*STP-209-1(2) Roadway and BHF-209-1(3) Bridge  
Widening of SR 74 From SR 85 to*

*P.I. Nos. 322355 and 322357*

**Value Engineering Study Report**

Preliminary Design Stage

ALTERNATIVE 6  
 ORIGINAL  
 DESIGN  
 SHEET 2 OF 3

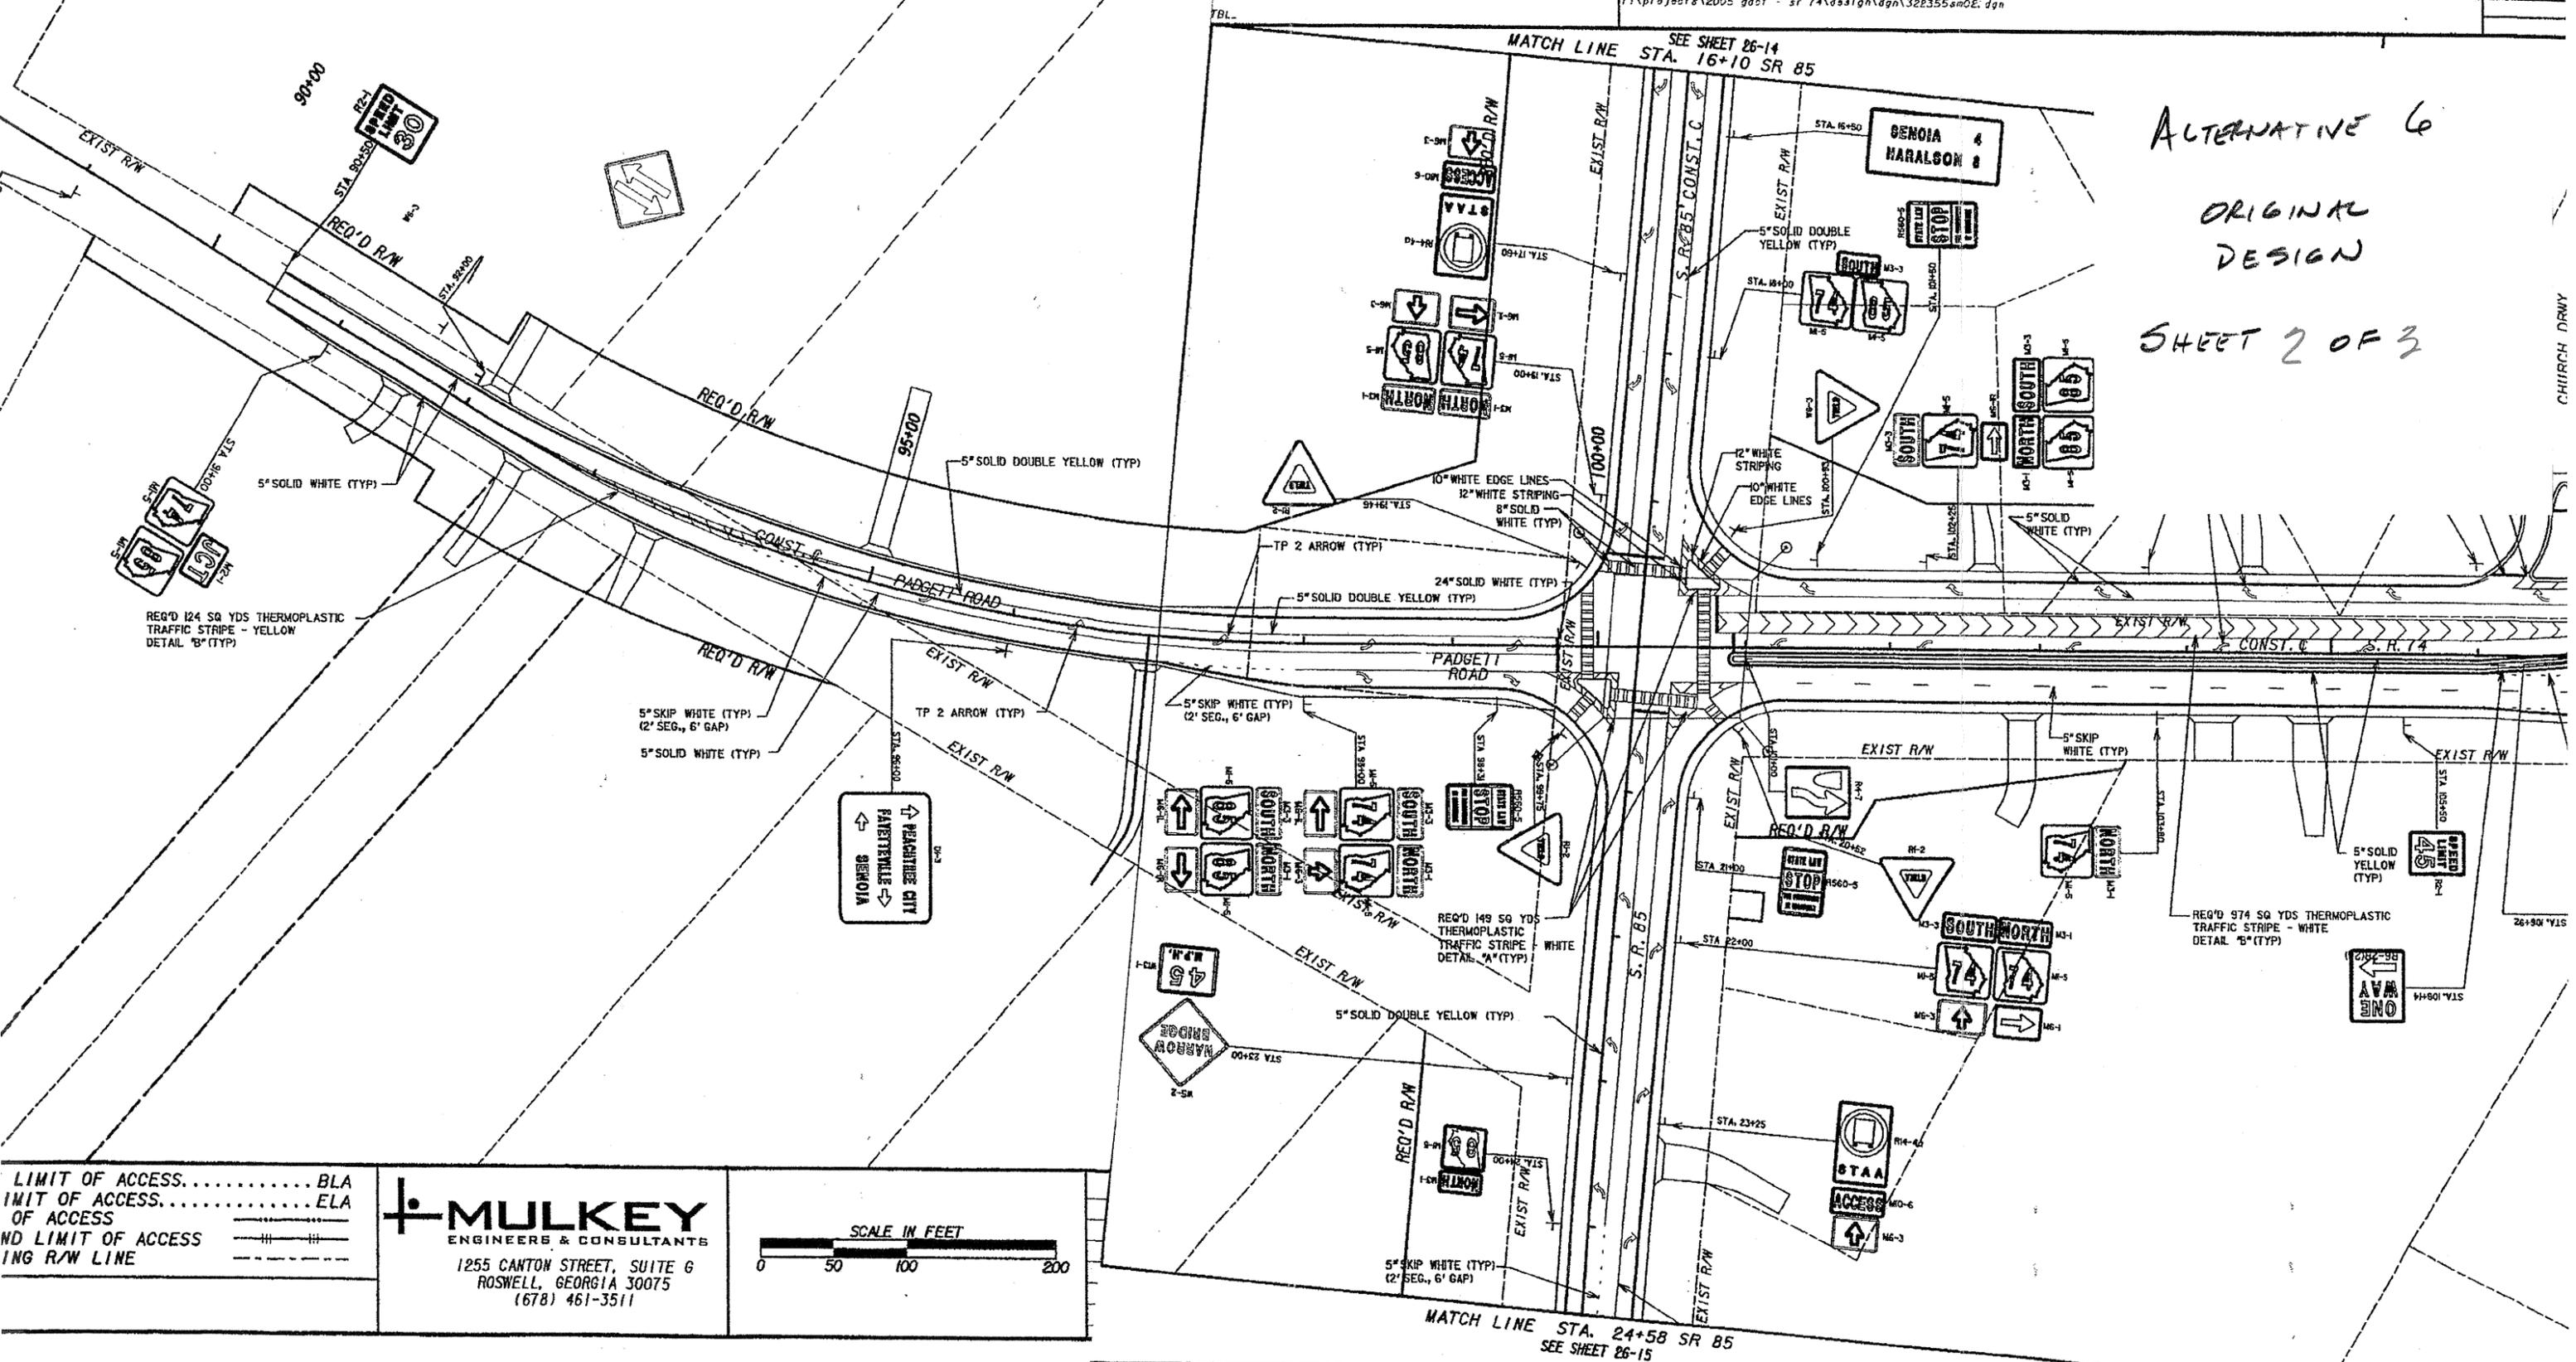
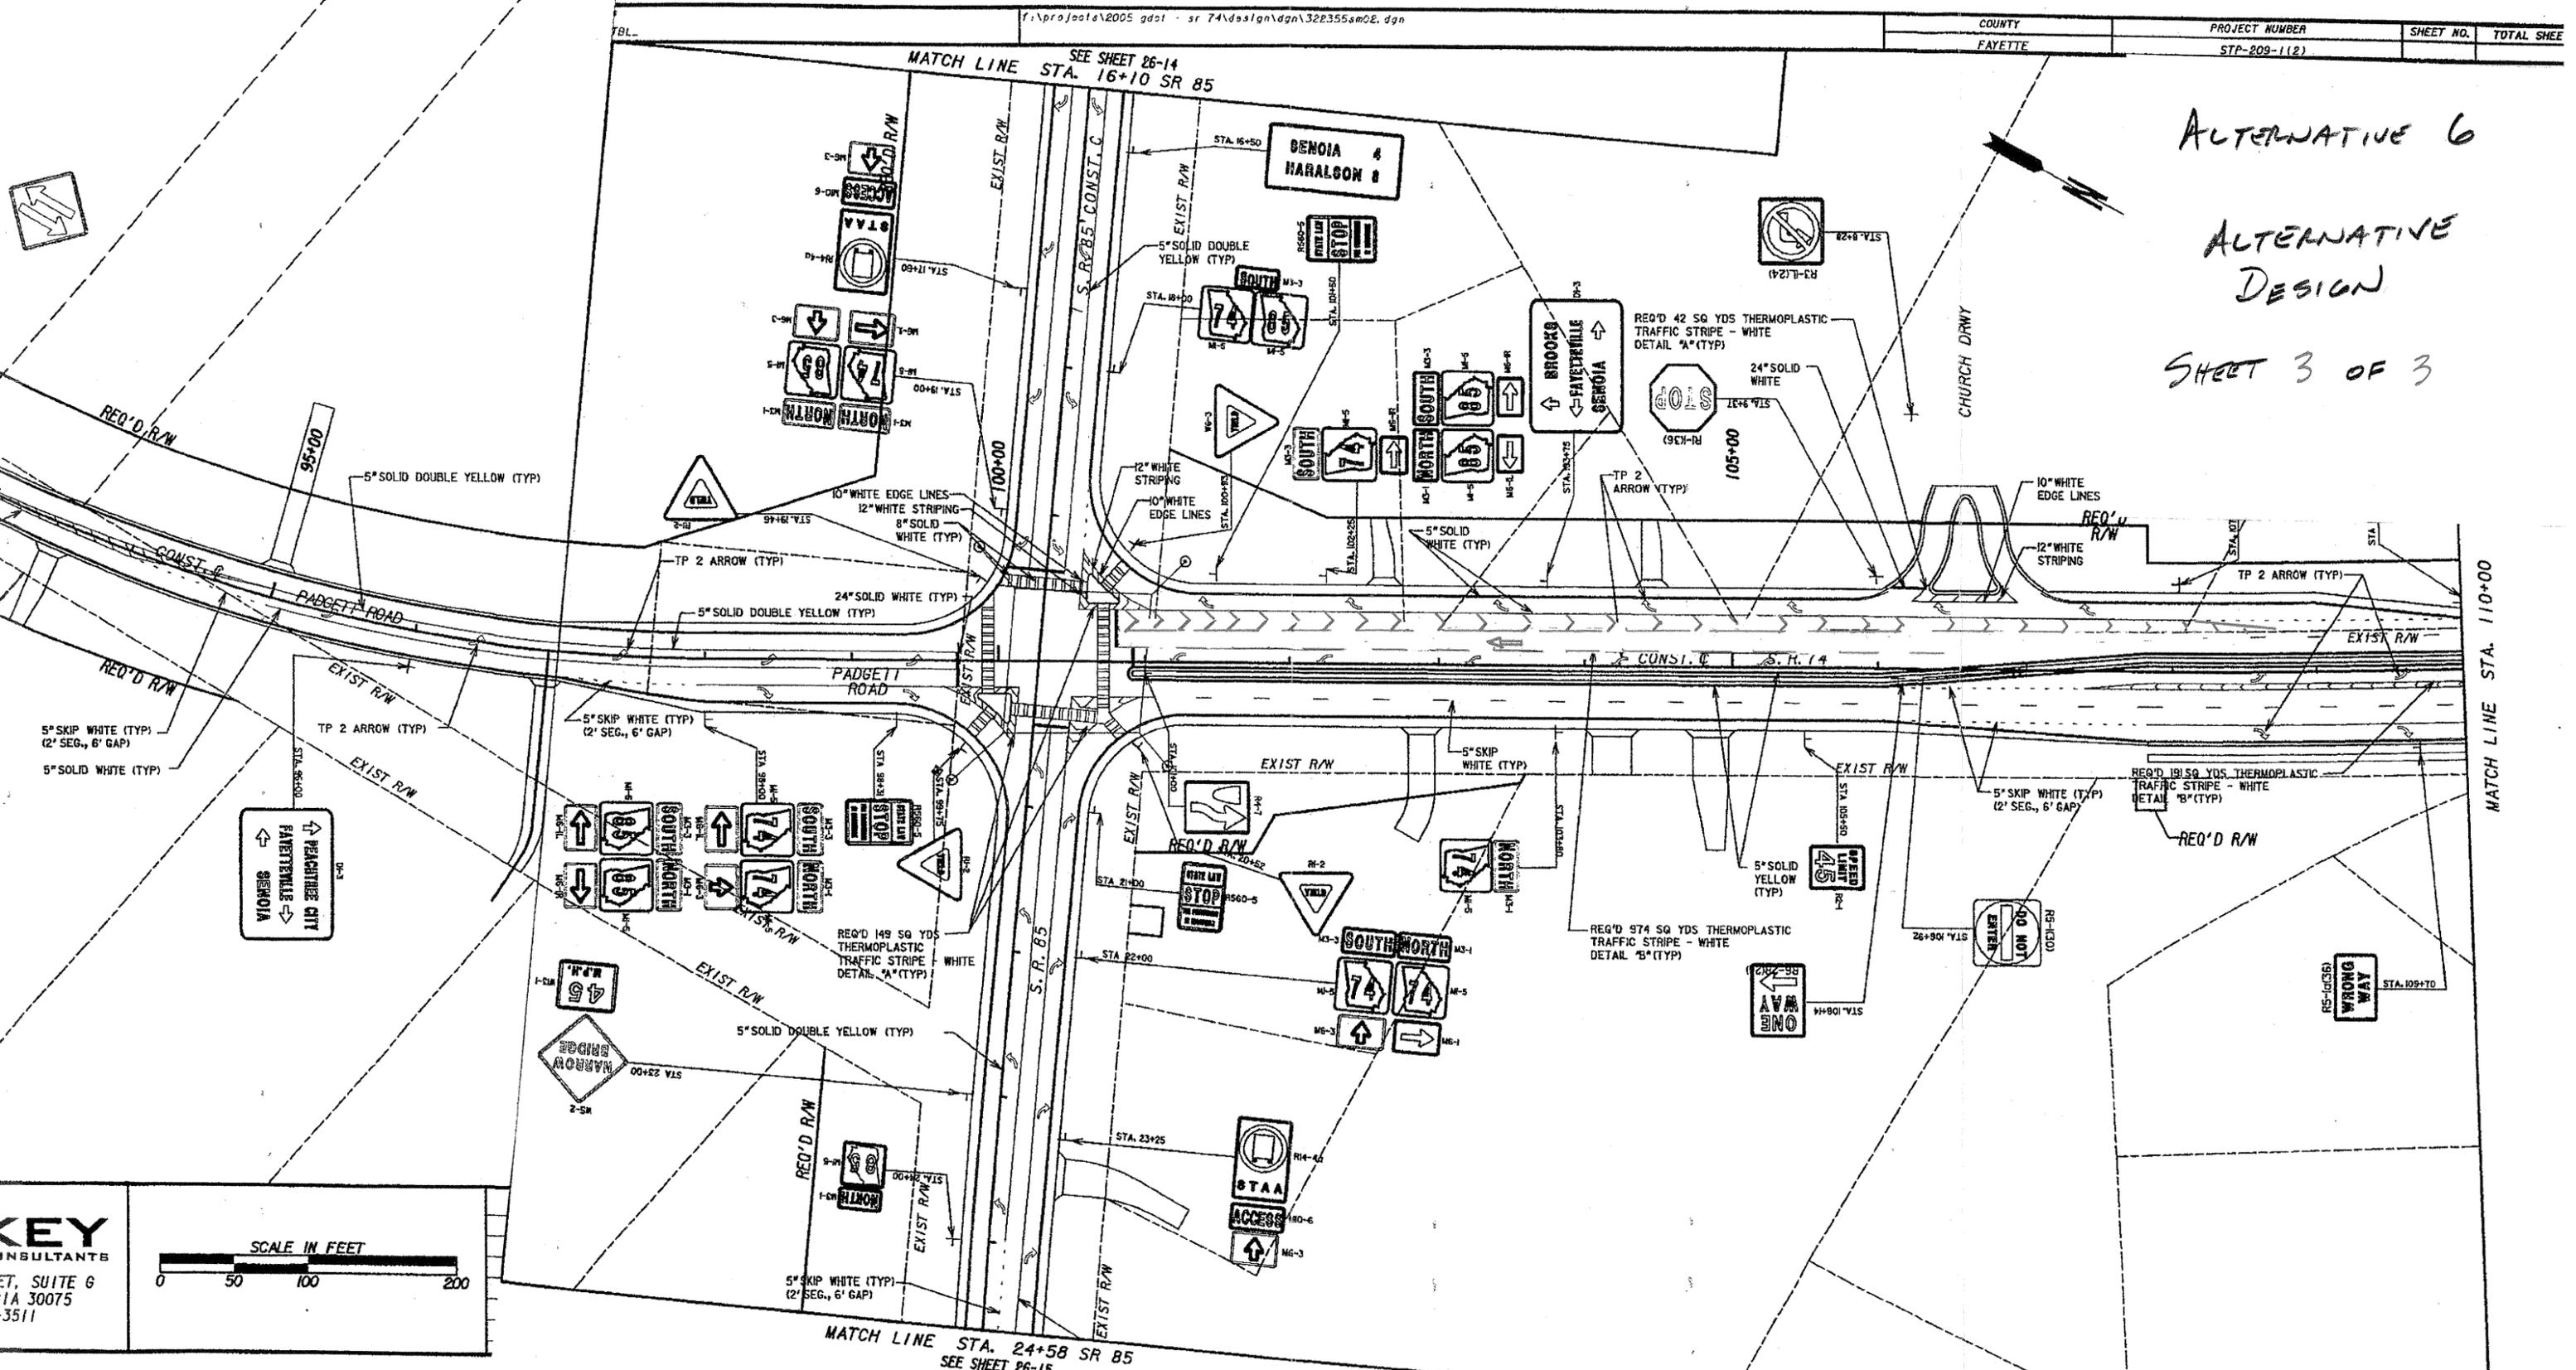
DESCRIPTION: **ALIGN SOUTHBOUND THROUGH LANE OF SR 74 WITH PADGETT ROAD** SHEET NO.: **1 of 3**

When SR 85 is widened to four lanes, if that is the case, the Padgett Road side of the intersection can be modified at the time of the SR 85 project to maintain the alignment.
